From: Isabella Mash <isabella.mash@dhaplanning.co.uk>
Sent: 17 November 2025 11:56:52 UTC+00:00
To: "Joseph Swift" <joseph.swift@midsussex.gov.uk>
Cc: "Lauren Sinden" <Lauren.Sinden@dhaplanning.co.uk>
Subject: Re: DM/25/2187 - Land To The West Of Freeks Lane (Phase 3)
Attachments: S0035_HB3_BLOCK_0214_C3 - HT D - PLOTS 173, 174, 175, 176, 237, 238, 240, 241, 256, 257, 278, 279, 294, 295, 324, 325.pdf, S0035_HB3_ELEV_0314_C3 - HT D - PLOTS 173, 174, 175, 176, 237, 238, 240, 241, 256, 257, 278, 279, 294, 295, 324, 325.pdf, S0035_HB3_PL101_P1 - Block 12 and Plot 323 Elevations.pdf, A-SC-HB3-010_C1_MATERIALS SCHEDULE.pdf, IMG_6915.jpg

RE: Discharge of planning condition no 1 (Phase 3) relating to planning application DM/19/3845.

AT: Land To The West Of Freeks Lane, Burgess Hill, West Sussex

REFERENCE: DM/25/2187

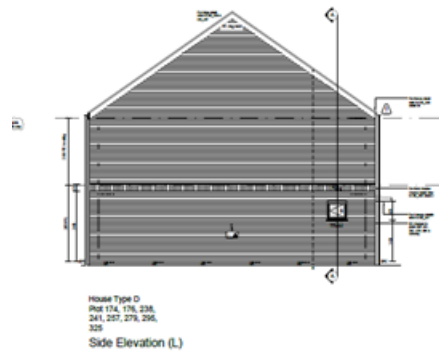
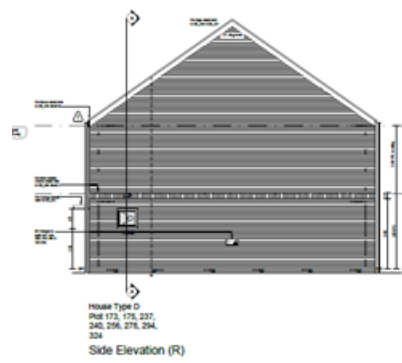
As per the following plans in relation to block 12, it does not appear that any additional fenestration has been added to the western flank elevation:

As approved:

As submitted as part of the discharge of conditions:

Officer Comment	Applicant Comment
Condition 1 in part states: ‘Re-designed corner flanks incorporating additional fenestration on plots 15, 19, 20, 24, 25, 26, 29, 38, 173, 441 and block 12's west flank and block 14's east flank.’ As per the following plans in relation to block 12, it does not appear that any additional fenestration has been added to the western flank elevation.	The elevation is screened by Plot 323 and lies approximately 1.1 m from the site boundary, as illustrated in new streetscene elevation (Elev A) and side elevation (Elev B) plan reference S0035_HB3_PL110 (attached). Additional fenestration in this location is therefore not proposed, and this has been accepted in relation to apartment block 6.

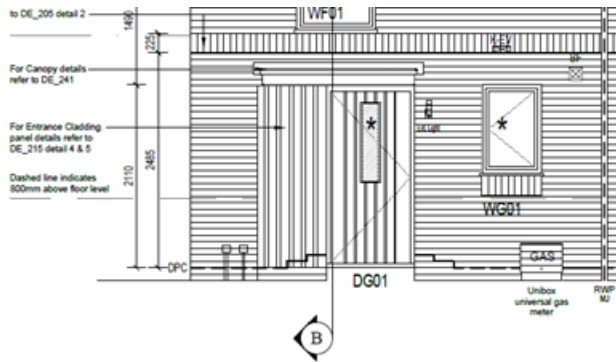
This is the same for Plot 173, no additional openings have been provided to the flank elevations:

This is the same for Plot 173, no additional openings have been provided to the flank elevations.	 House Type D Plot 173, 175, 237, 240, 256, 278, 294, 324 Side Elevation (R)	Additional living room side window now shown as per new plan ref. S0035_HB3_ELEV_0314
In addition, we don't appear to have details of the cladding (colour) adjacent to the door and the reference does not match the submitted plans (DE 215).		Noted on Material Schedule – see attached.
Furthermore, is it proposed for the glass to be obscure glazed? We would prefer this to be clear glazed.		Obscure glazing is proposed only for the front door, WC, bathroom & en-suite, as shown by the hatched markings on the elevations.
Finally in the relation to the gas boxes, please can you provide us with an image of how this would look, is there a reason they are located to the front? Can they not be more discreetly located?		Gas meter located to be adjacent to internal boiler and to avoid driveway locations. See photograph attached; please also note that this is freshly planted vegetation (a week or so old), once established the gas metre will be fully hidden.
